ADDENDUM 2

DATE: February 22, 2017
PROJECT: JLL Roof Replacement and Waterproofing Project
RFP NO: 744-R1712
OWNER: The University of Texas Health Science Center at Houston
TO: Prospective Proposers

**UNIVERSITY OF TEXAS HEALTH SCIENCE CENTER
JESSE JONES LIBRARY
ROOF REPLACEMENT AND EXTEIOR WALL REPAIRS/RESTORATION
1133 JOHN FREEMAN BOULEVARD
HOUSTON, TEXAS**

**ADDENDUM NO. 1
FEBRUARY 17, 2017**

1 EXISTING ROOF PLAN:
 R2.00 SCALE: 1"=20'-0"(11"x17"); 1"=10'-0"(22"x34")

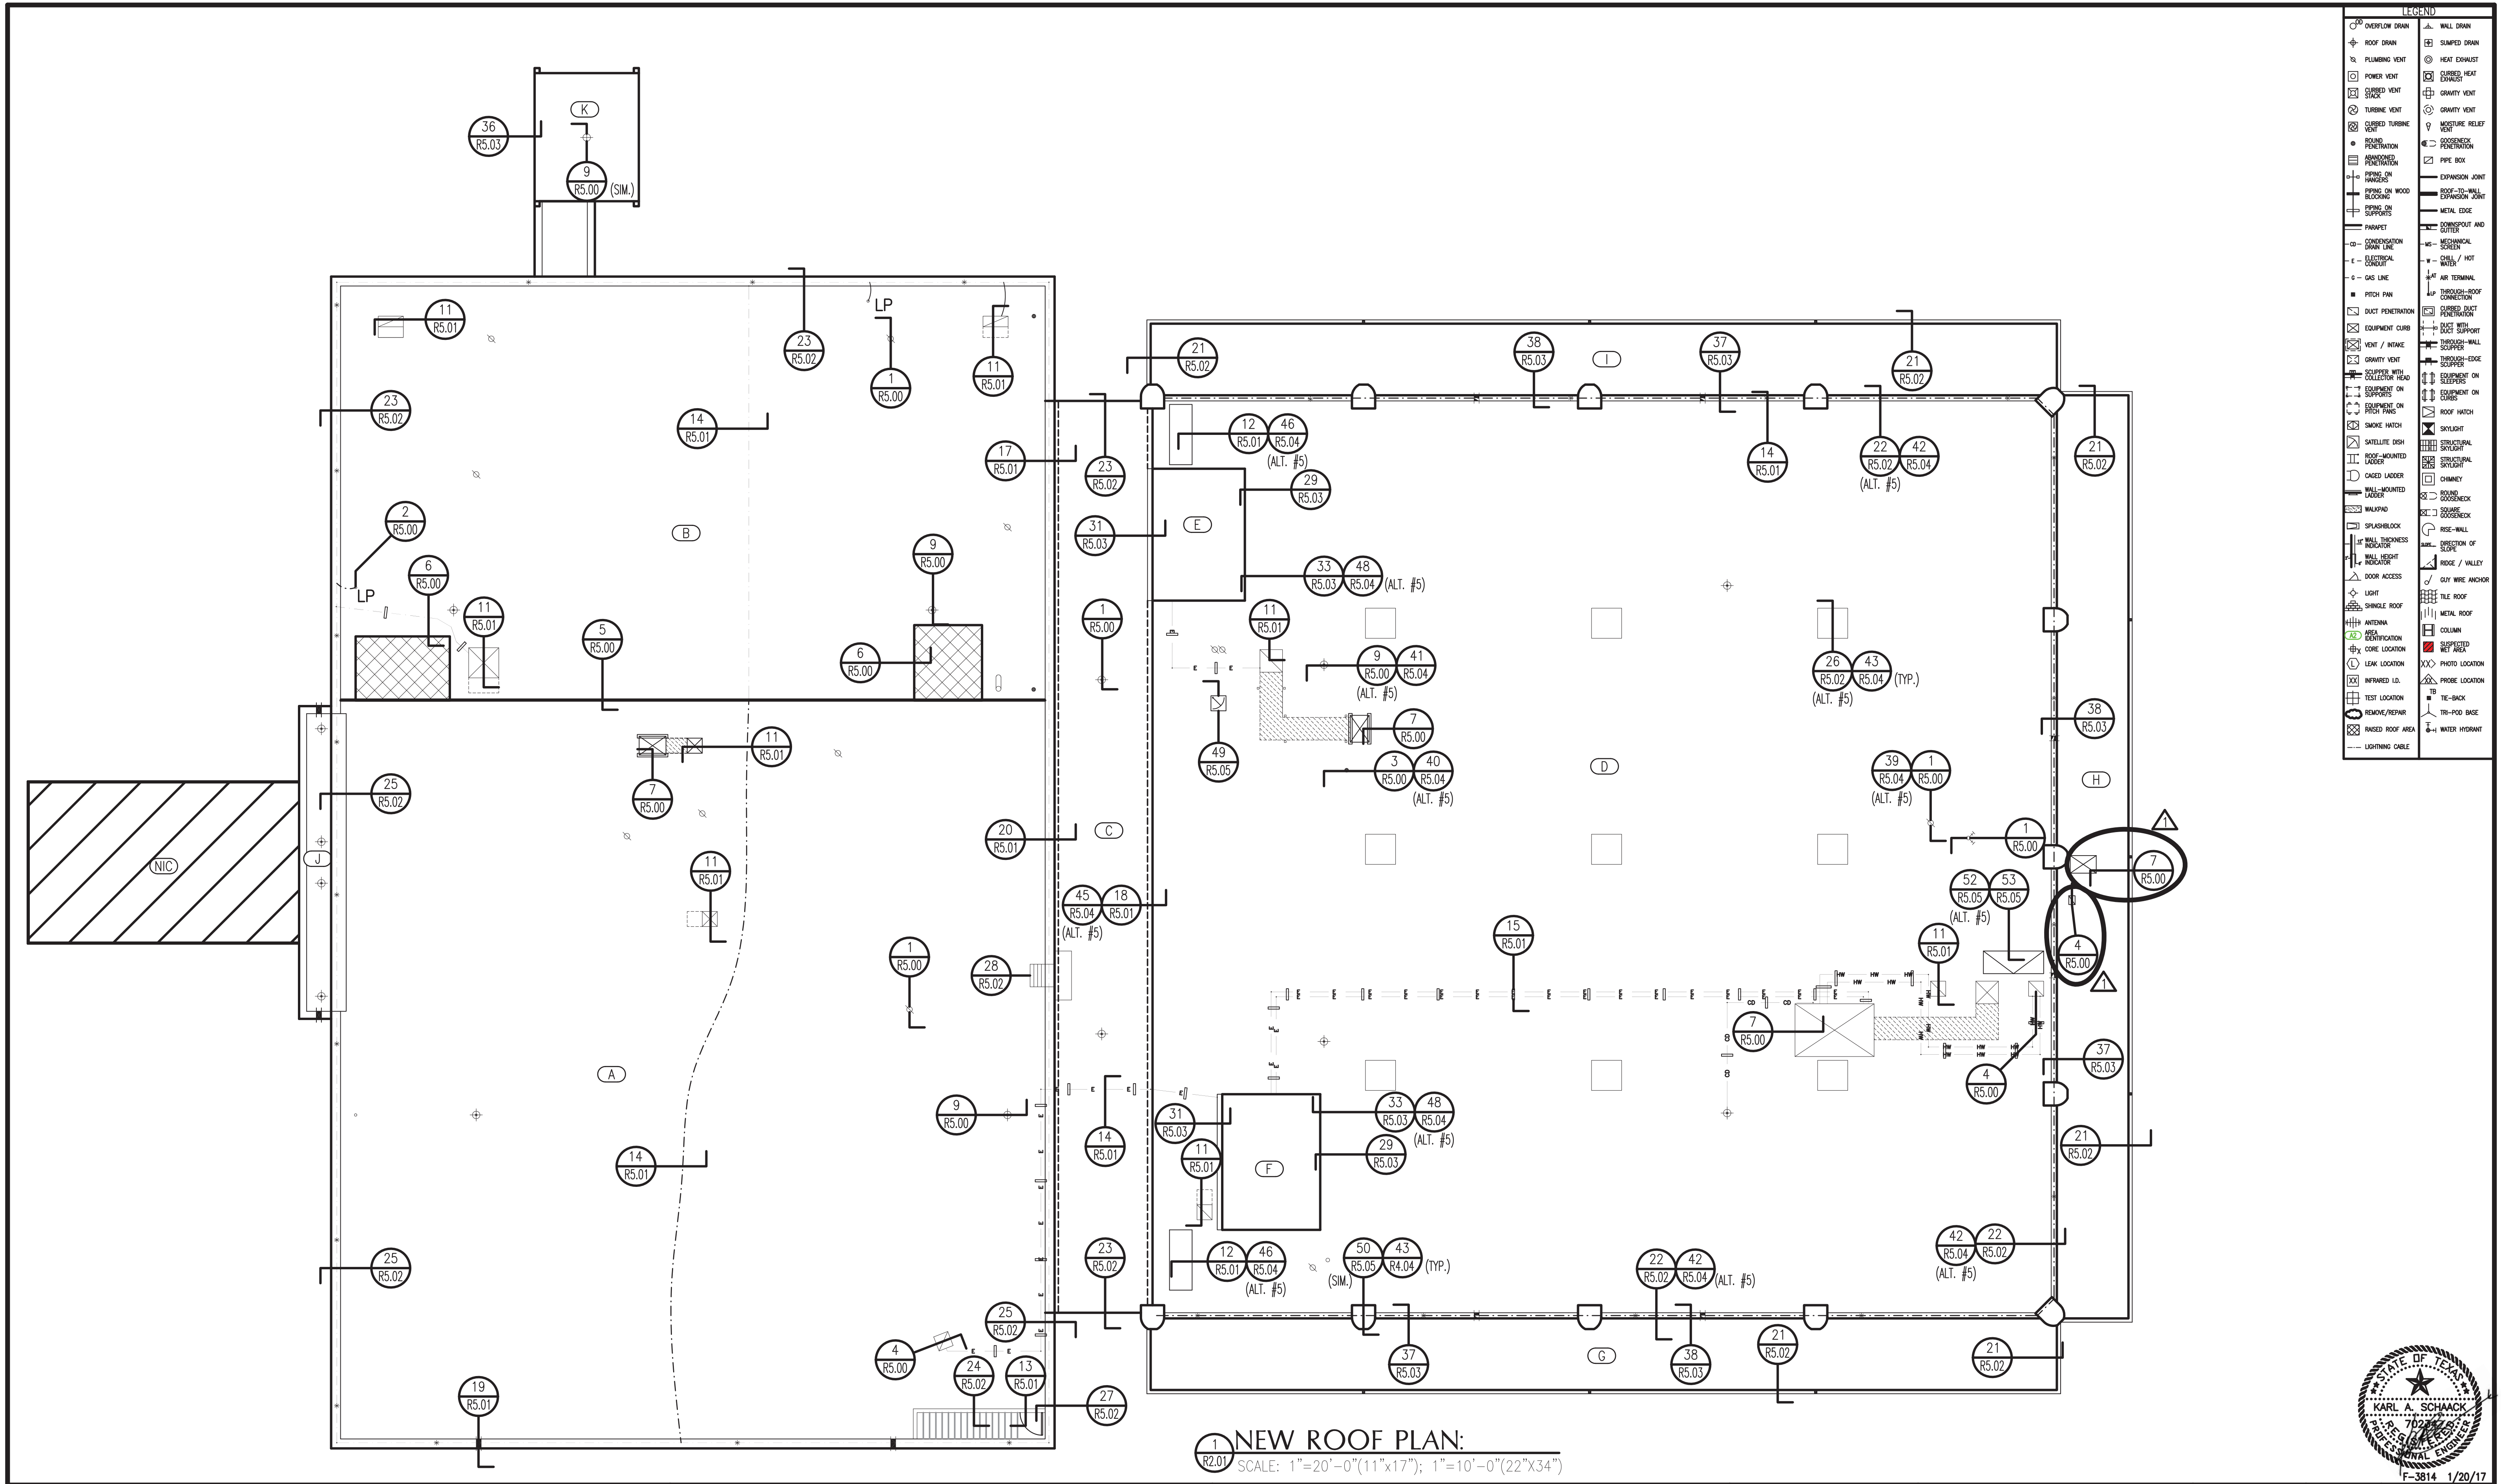
5. Sheet R2.00 – Existing Roof Plan: Add illustration of equipment supported by sleepers and pipe box penetration on roof Area “H”. Reference attached revised Sheet R2.00.

1 NEW ROOF PLAN:
 R2.01 SCALE: 1"=20'-0"(11"x17"); 1"=10'-0"(22"x34")

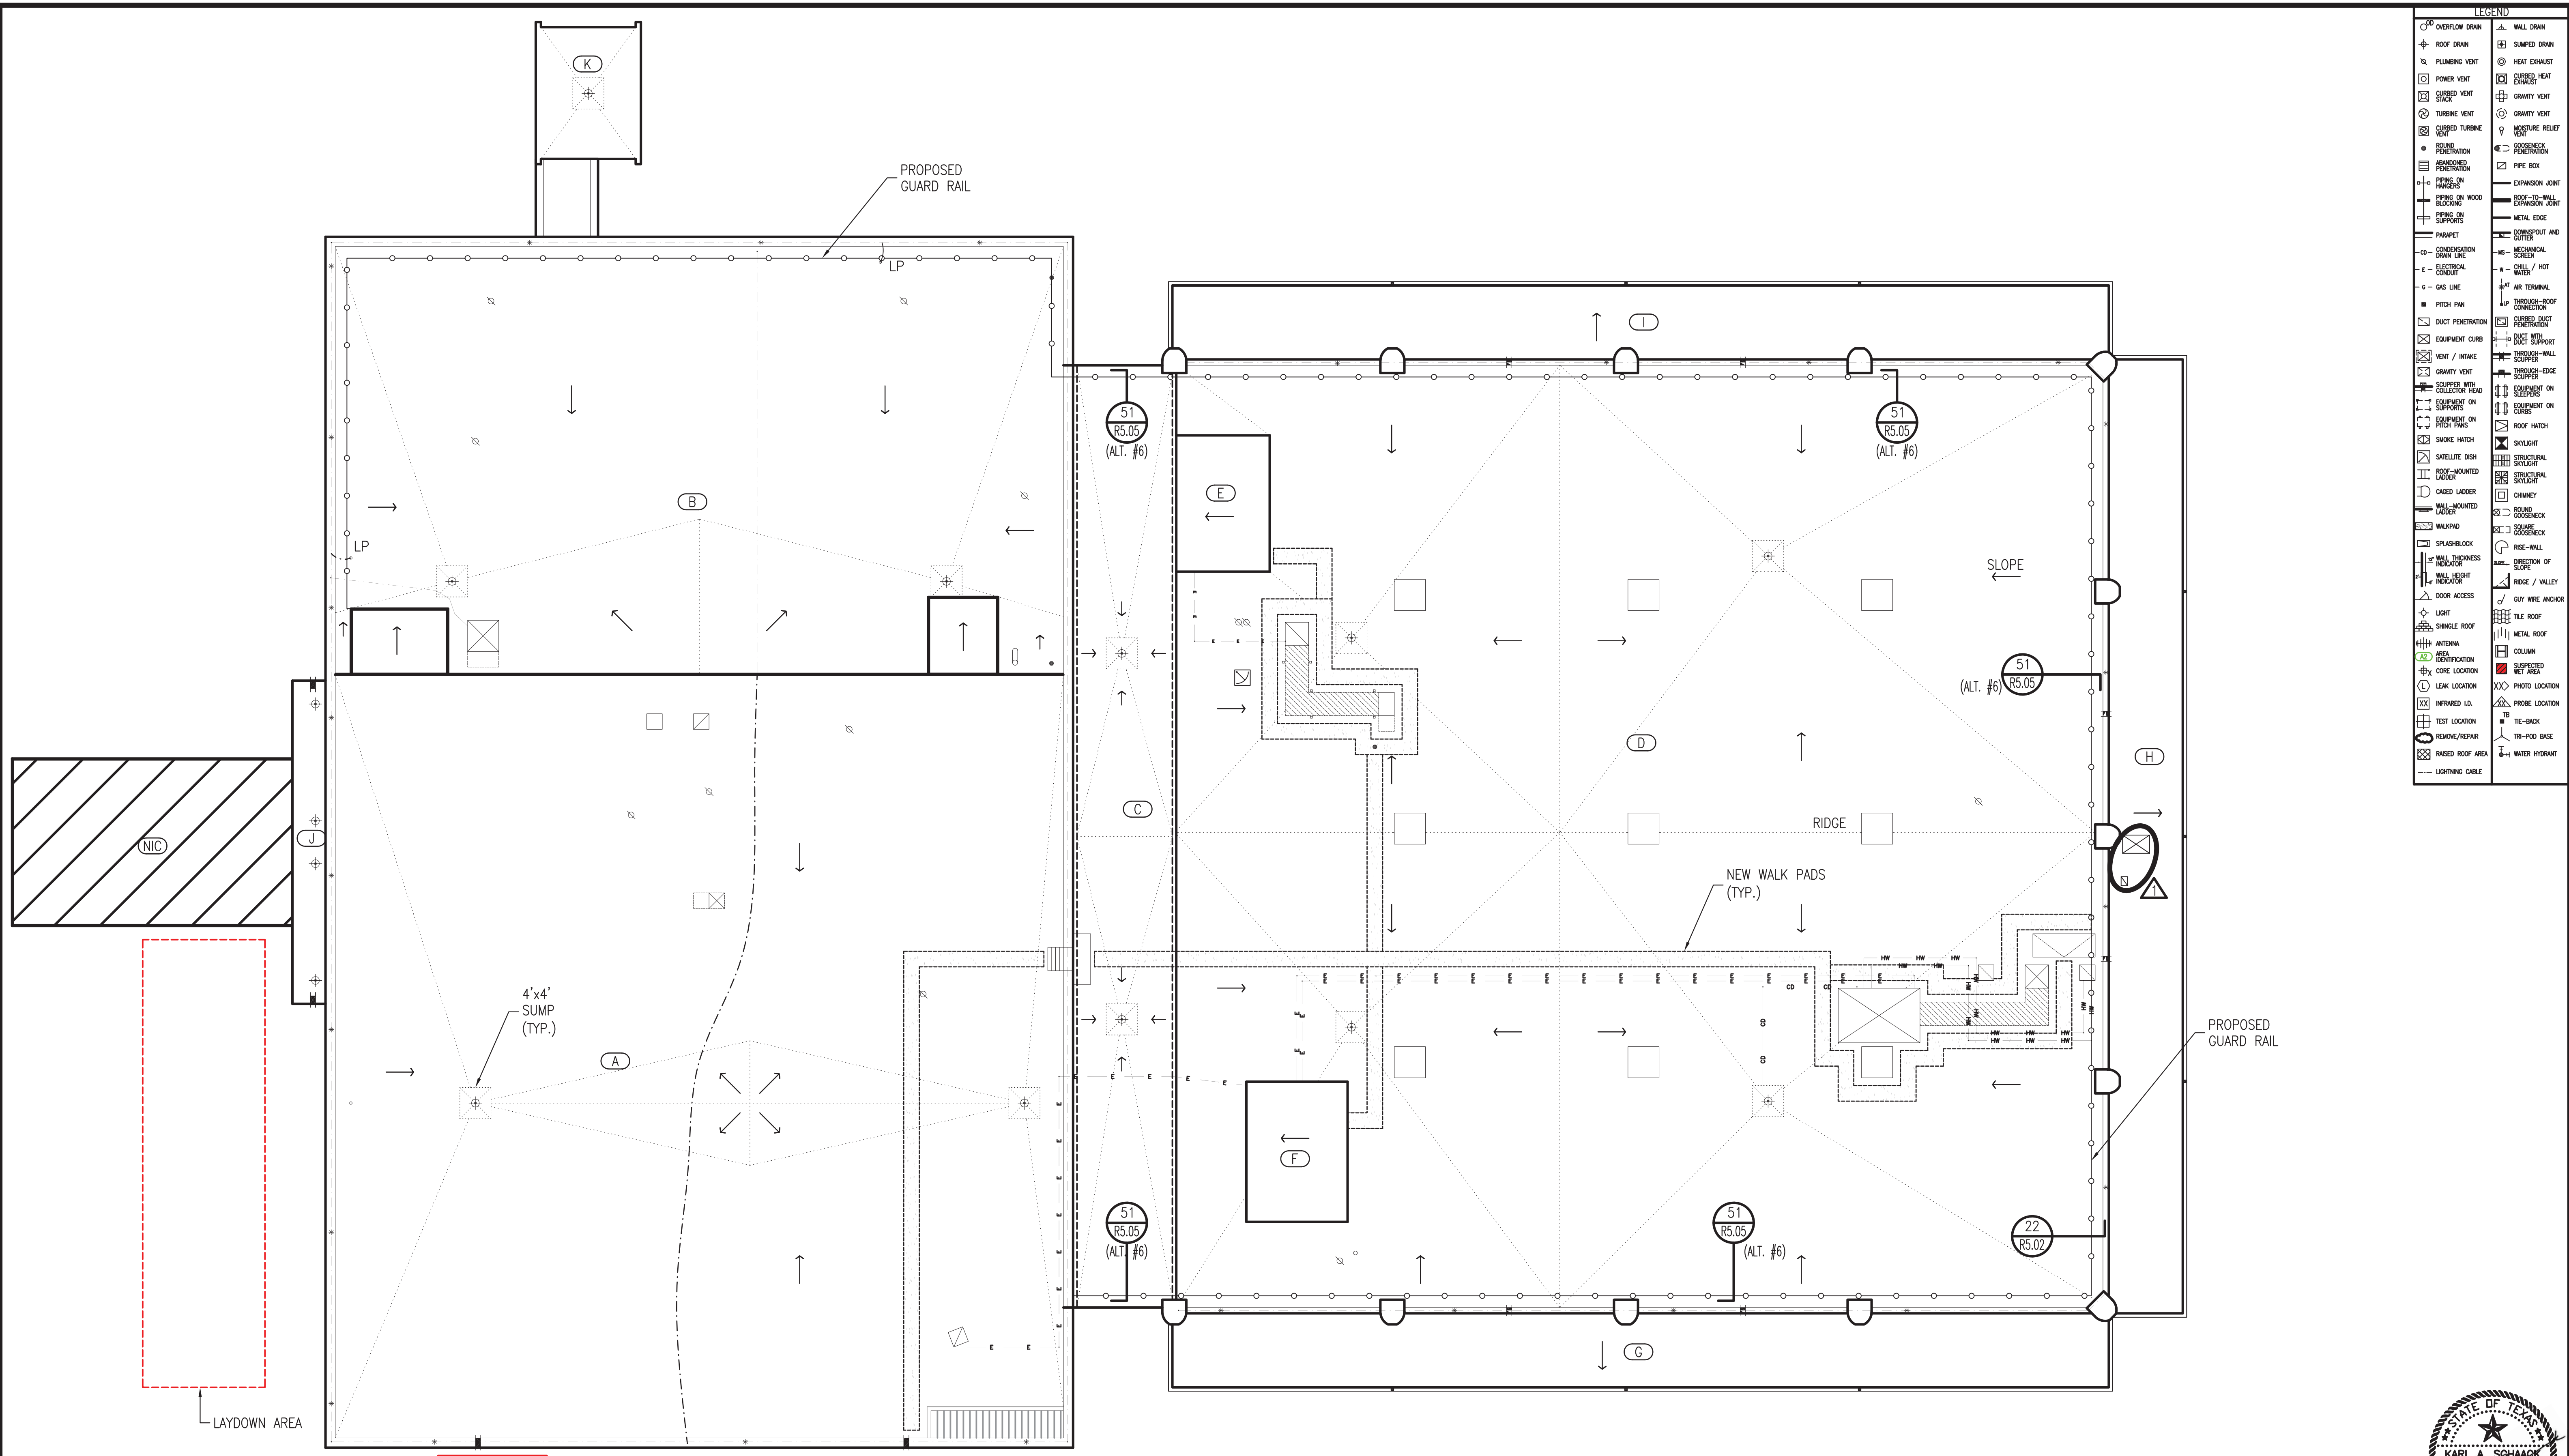
6. Sheet R2.01 – New Roof Plan: Add illustration and detail designations of equipment curb and pipe box penetration on roof Area “H”. Reference attached revised Sheet R2.01.
